Federal Aviation
Administration

ZODIAC CH 601 XL AIRPLANE SPECIAL REVIEW TEAM REPORT JANUARY 2010

Figure 1: Comparison of FAA Estimated Loads with 'Zodiac CH 601 XL Stress Analysis and Tests'

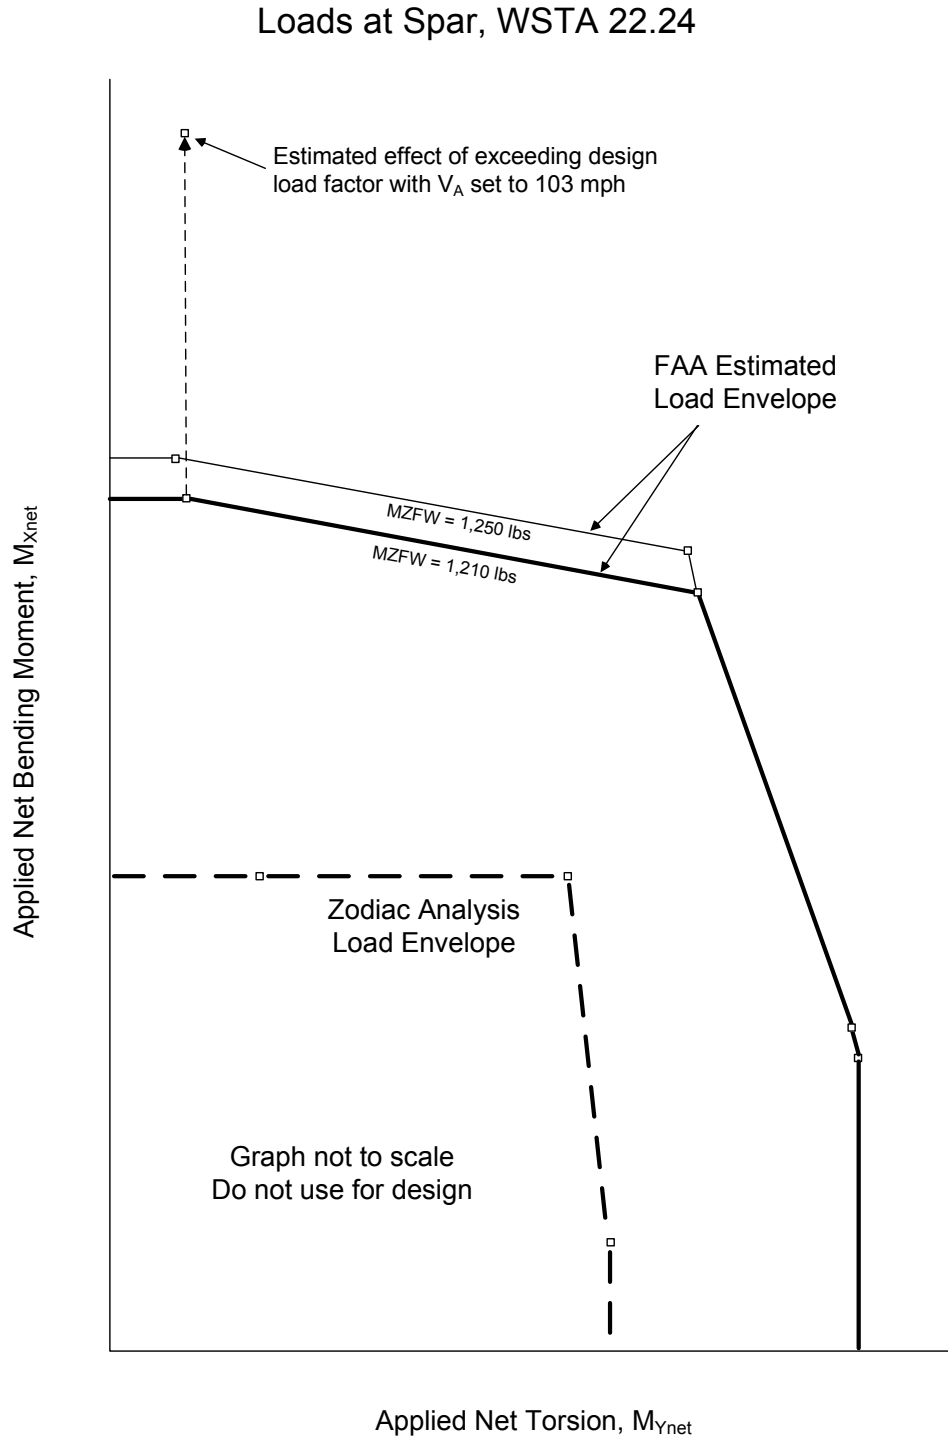
During our review, the FAA developed estimates of the wing bending and torsion loads to determine the relative importance of each of these issues. We estimated the wing loads assuming a minimum value for the MZFW of 1,210 lbs, based on an empty weight of 830 lbs and 380 lbs for the occupants. We also studied the effects of providing an increased MZFW of 1,250 lbs to account for differences in empty weight across the existing fleet, additional installed equipment (e.g. ballistic recovery systems), and for potential structural modifications to the design. Our estimated wing bending and torsion loads are significantly higher than those computed by the manufacturer, as shown in figure 1. (Note: We have removed the actual load values from figures 1 through 4 to protect the manufacturer's proprietary information and data.)

Figure 2: Effect of Pitching Moment Characteristics on Wing Design Loads

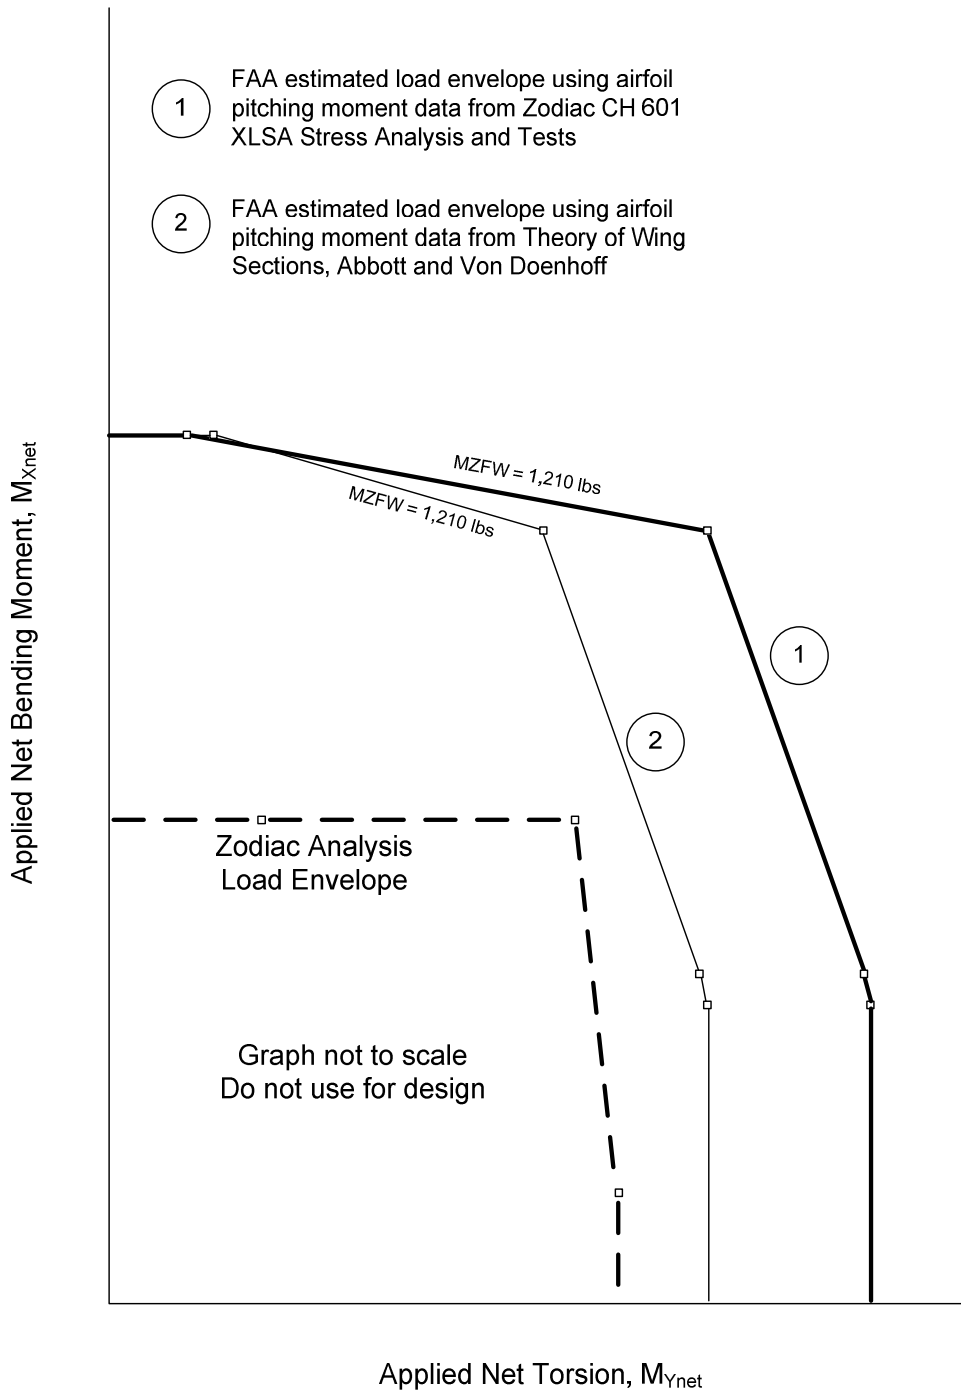
The FAA also studied the importance of the airfoil pitching moment data. As shown in figure 2, the accuracy of this data is critical in determining the torsion loads the manufacturer must use to design the wing. For comparison to the manufacturer's data during the completion of this study, we used wind tunnel test data from the widely used academic publication 'Theory of Wing Sections' by Abbott and Von Doenhoff for an airfoil that appeared to be similar to the one incorporated into the CH 601 XL wing.

Figure 3: Revised Zodiac Analysis and Static Test Wing Design Loads

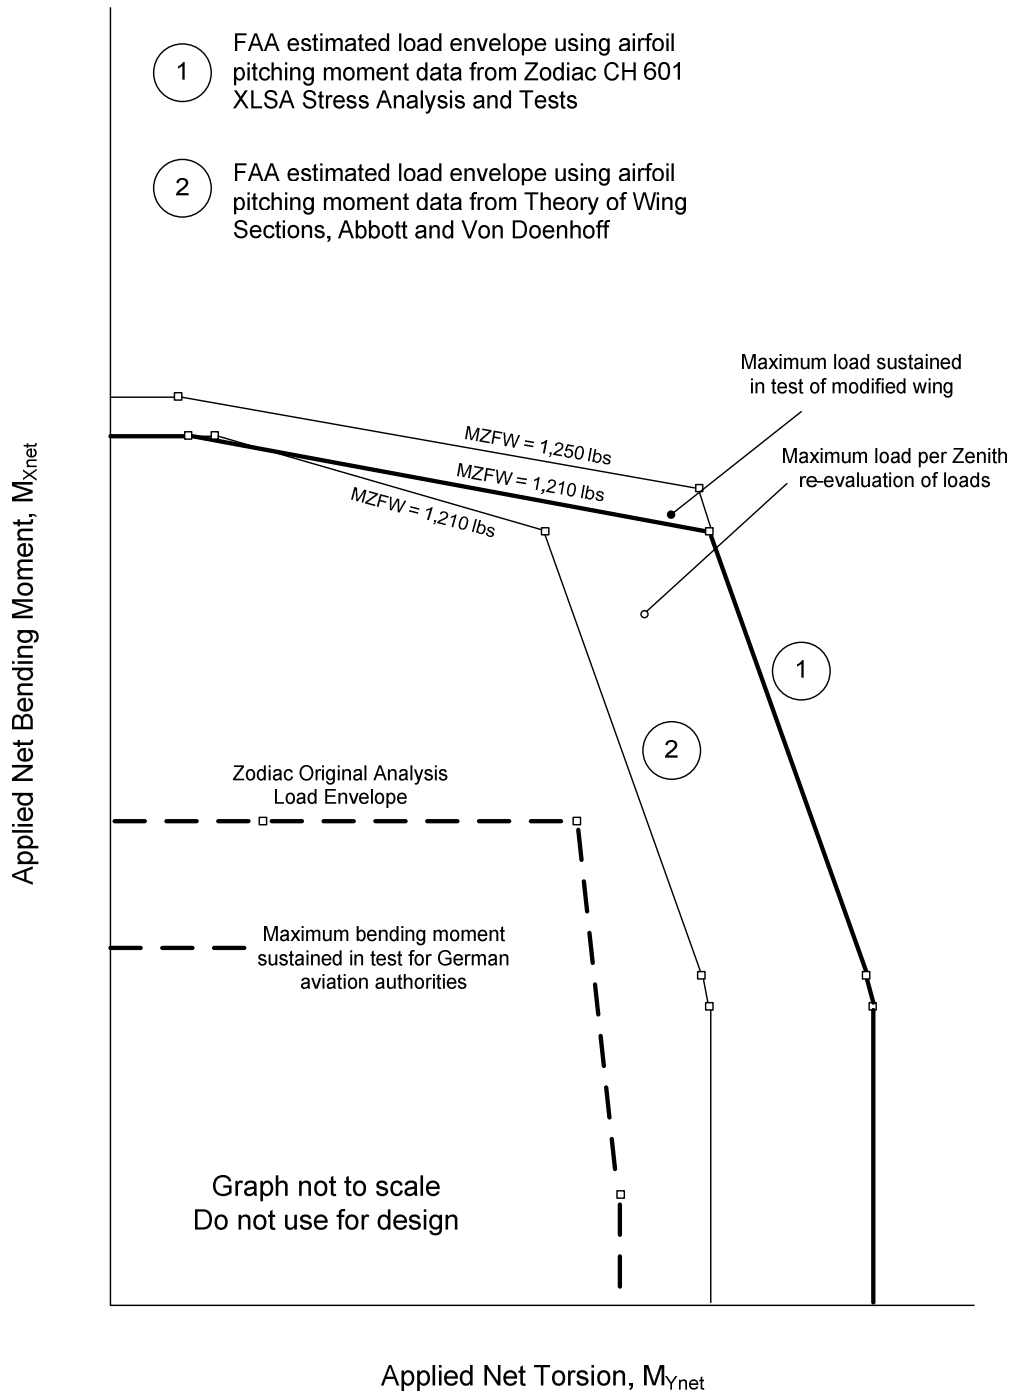
The manufacturer successfully tested the modified wing structure to loads higher than determined in their revised analysis. The wing structure did not fail at the ultimate test loads. However, the wing attachment bolts were bent and the attachment bolt holes were elongated, indicating there was permanent damage to the structure at these loads. We have depicted the loads from the manufacturer's revised analysis and static test in figure 3.

- The manufacturer stopped the static test of the modified structure approximately five percent below the FAA’s load estimates required for ASTM compliance. At the time of this report, the manufacturer was continuing to make modifications to the wing structure and the drawings referenced by the safety directive to provide further improvements. The manufacturer should consider additional structural testing and analysis once a final design is reached to demonstrate the new wing meets the ASTM standards.

Figure 4: History of Zodiac Wing Structural Loads Analysis and Tests

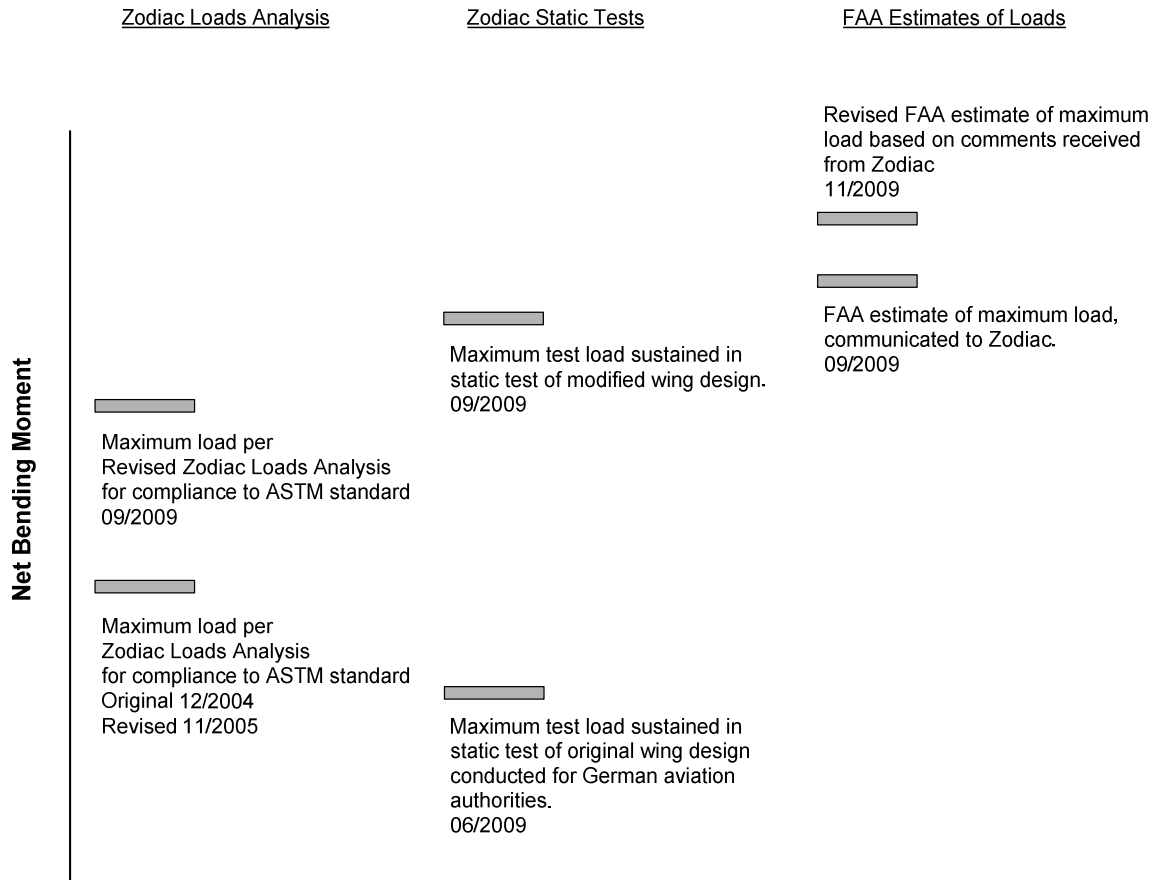
Figure 4 presents a history of the manufacturer's loads analysis and static testing. We provide this information to provide a time line of the manufacturer's structural analysis and testing.

Figure 5: CH 601 XL Stick Force per g Evaluation

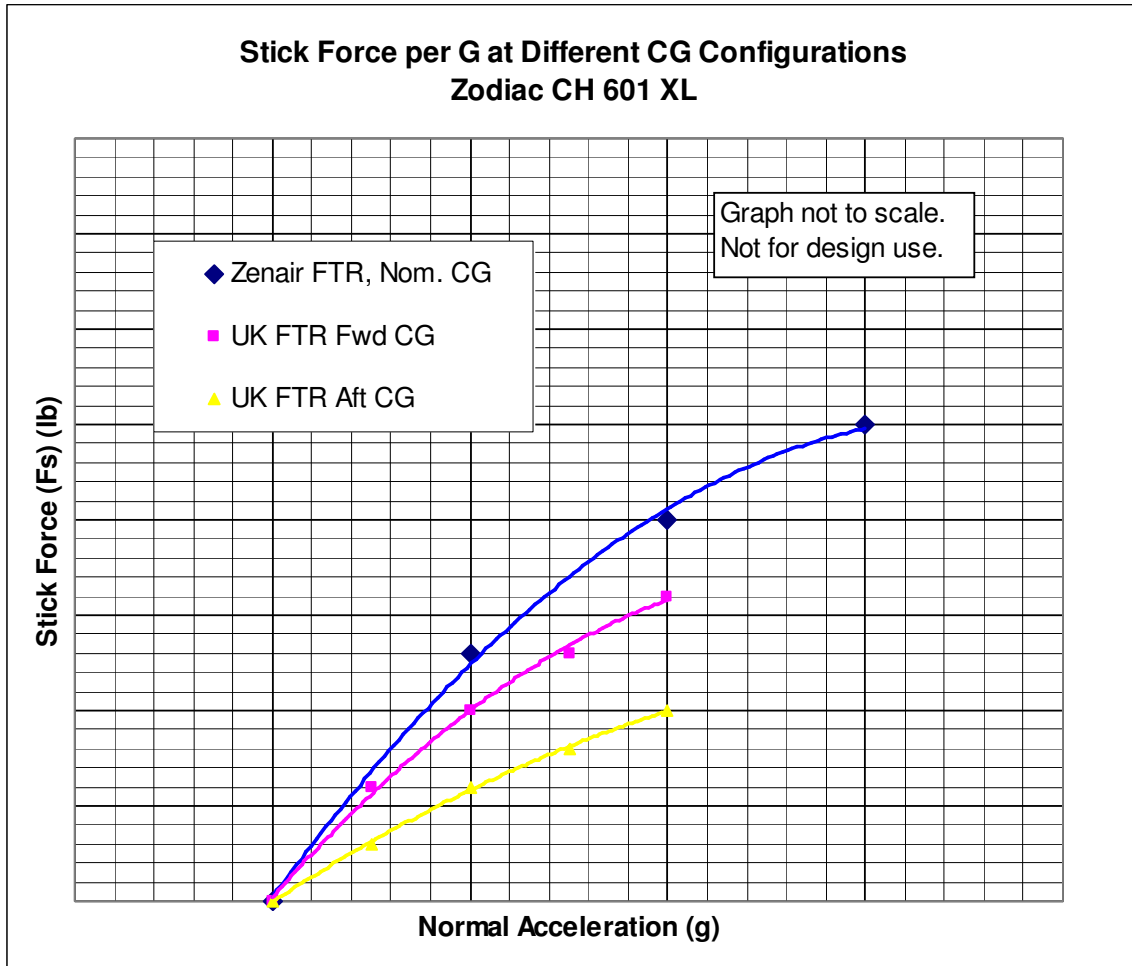
The UK LAA performed flight tests for a flutter mitigation program and provided the results to the FAA. Stick force per g evaluations were conducted at both forward and aft cg. Figure 5 shows the data they obtained appears to be compliant with the ASTM standards as well as with 14 CFR Part 23 § 23.155(c). (Note: We have removed the actual stick force and g load values from figure 5 to protect the manufacturer's proprietary information and data.)

Though not required to do so, it appears their tests followed the guidance provided by AC 23-8B. However, when applying this guidance to aft center of gravity data to match compliance with 14 CFR Part 23 § 23.155(a), Figure 5 shows the stick force at limit load appears to extrapolate to a value slightly less than the 15 pound minimum requirement at limit load. Though the CH 601 XL does not have to comply with 14 CFR Part 23, the data does indicate that stick force gradients may not be acceptable for aircraft that are intentionally or unintentionally flown outside the POH center of gravity limits. This is simply presented for regulatory comparison, as 14 CFR Part 23 § 23.155(a) is not currently reflected in the ASTM standards at any center of gravity configuration.

- AC 23-8B, Paragraph 51(a) which describes why testing at aft center of gravity configurations is important to evaluate stick force.
 - AC 23-8B, Paragraph 51(d) which quantifies minimal stick force per g gradients for both stick and wheel controlled airplanes.

Figure 6: Standard Day Correction Effects on CH 601 XL Airspeed Calibration

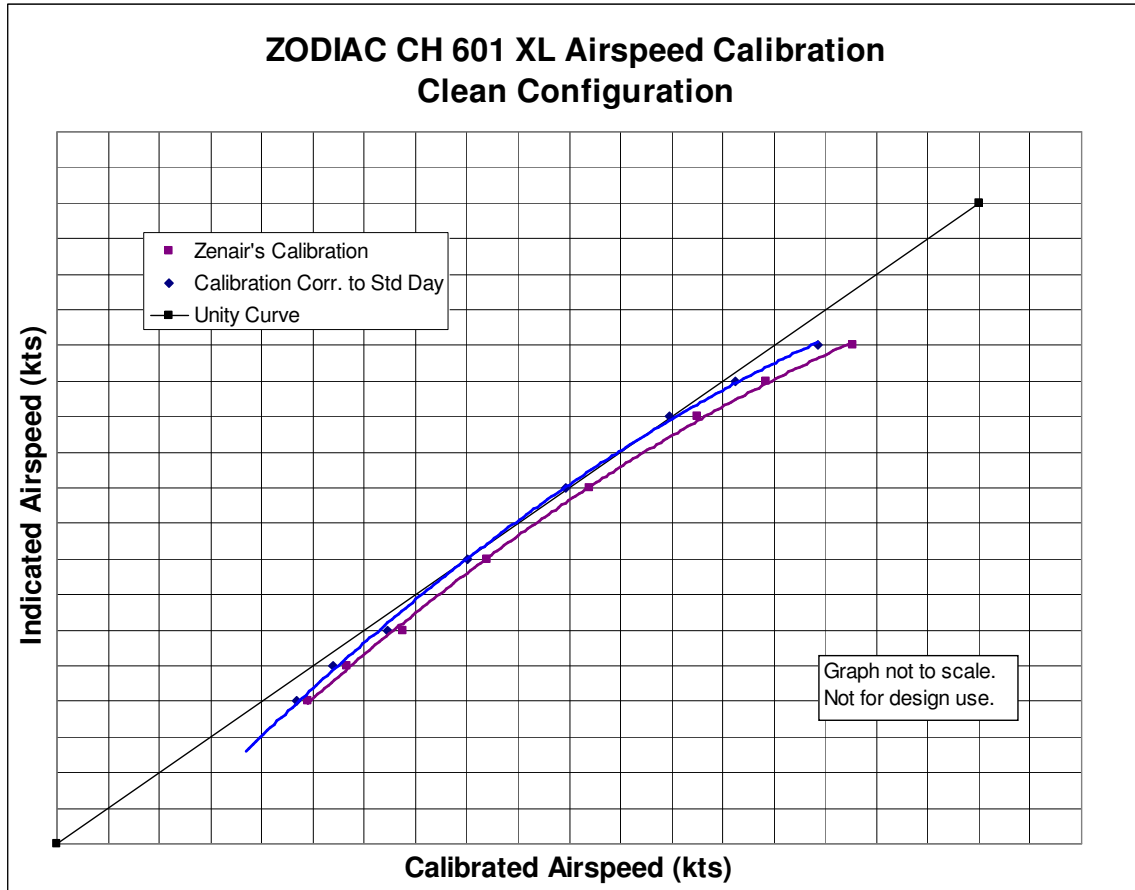
The manufacturer's flight test report was reviewed. It appears the airspeed calibration data presented was only calibrating indicated airspeed to true airspeed. Since this data was collected at a non-standard day temperature of 31°C, and at an altitude other than sea level, a density correction must be applied to the true airspeeds to accurately determine the calibrated airspeeds (compressibility effects are not applicable to light sport airplanes). Figure 6 shows the effect of applying a standard day correction to the airspeed calibration. (Note: We have removed the actual airspeed values from figures 6 through 8 to protect the manufacturer's proprietary information and data.)

Regarding stall speed, the manufacturer's flight test report determined the flaps up stall speed to be 35 knots indicated airspeed (KIAS) (40 mph) which was reported as 43 knots calibrated airspeed (KCAS) (50 mph). In reality, it was 43 knots true airspeed (KTAS) (49 mph), which after correcting to standard day conditions; the stall speed is calculated to be 41 KCAS (47 mph). The manufacturer's Airplane Flight Manual (AFM) reported a 43 knot (49 mph) flaps up stall speed indicating that standard day corrections were not applied to the flight test data.

Figure 7: Zodiac CH 601 XL Airspeed Calibration Comparison

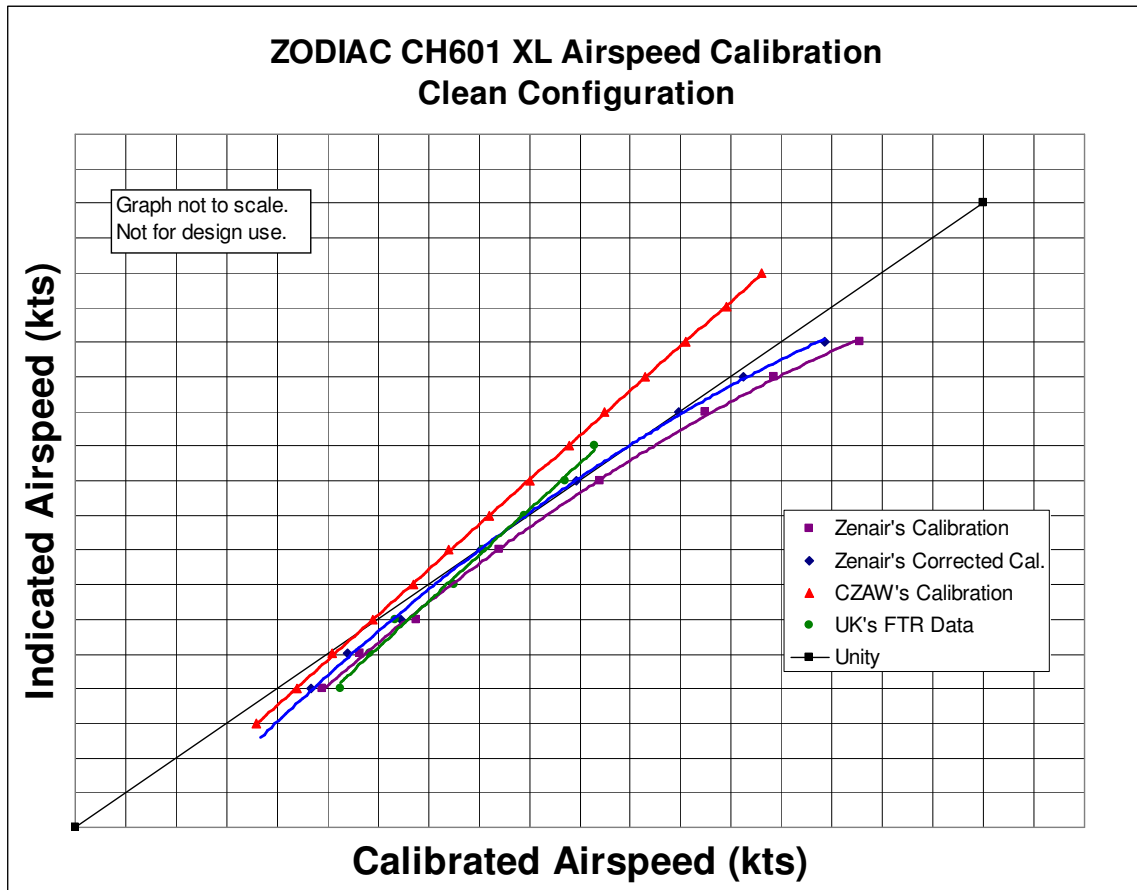
A comparison was made between CZAW and the manufacturer's airspeed calibrations. The calibrations were substantially different in both shape and magnitude. Without the flight test report, it is impossible to say which calibration is correct assuming that both designs are identical. Therefore, the potential to overspeed the aircraft exists. However, as part of the UK LAA flutter mitigation flight test program, an airspeed calibration was conducted and the results were overlaid with those from the manufacturer and CZAW, as seen in Figure 7. (Note: We have removed the actual airspeed values from figures 6 through 8 to protect the manufacturer's proprietary information and data.)

Figure 8: Zodiac Airspeed Calibration Evaluation per 14 CFR Part 23 § 23.1323(b)

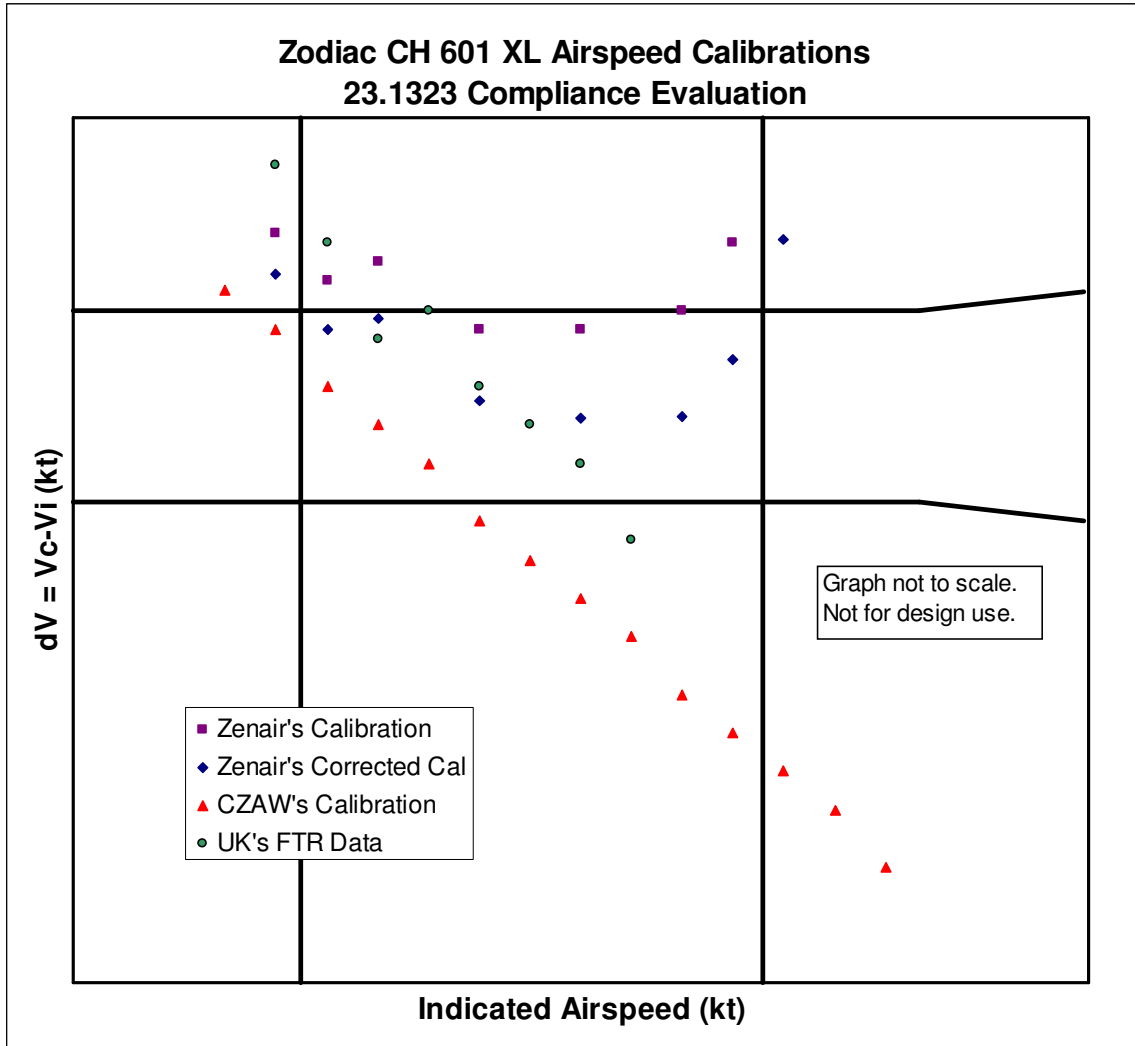
The UK LAA's flight test results are similar in magnitude to the manufacturer's data, but trend with CZAW's data making the comparison inconclusive. Using a different approach to determine the validity of the calibration data, a 14 CFR Part 23 § 23.1323(b) analysis was performed on these data sets and shown graphically in Figure 8. It should be

To evaluate the airspeed error per 14 CFR Part 23 § 23.1323(b), the error dV , must be less than ± 5 knots or 3% bounded by a lower airspeed of $1.3V_{S1}$ to a maximum airspeed of V_{NE} . Using the manufacturer's values, this means that to meet 14 CFR Part 23 § 23.1323(b), all the applicable data needs to fall in the enclosed ± 5 knot rectangle.
